# Access Compliance Report

## Public Rights-of-Way

### (Pedestrian Signals)

Intersection ID: N/A	Main Street:	Cross Street: N/A	Location: N/A
ADA ID: 69E0EBA4C786	Signal Type: One Push Button-Non APS	Overall Compliance: No	Severity Score: BTN 1: N/A BTN 2: N/A No BTN: N/A
Codes/Mitigation Info/Possible Solution		Field Measurements/Component Compliance

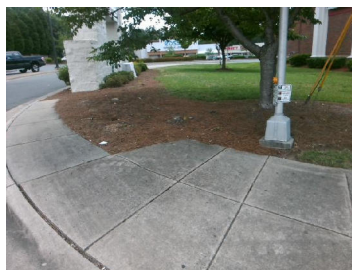
Surveyor Notes: TEXT HT 7/16

PROW/ADA: R410.6, TMUTCD 4e.08, R404.2, R406.2, R404.7.3

Possible Solutions: Replace Signal Push Button With APS Button on New Post. Remove & Replace Sign.
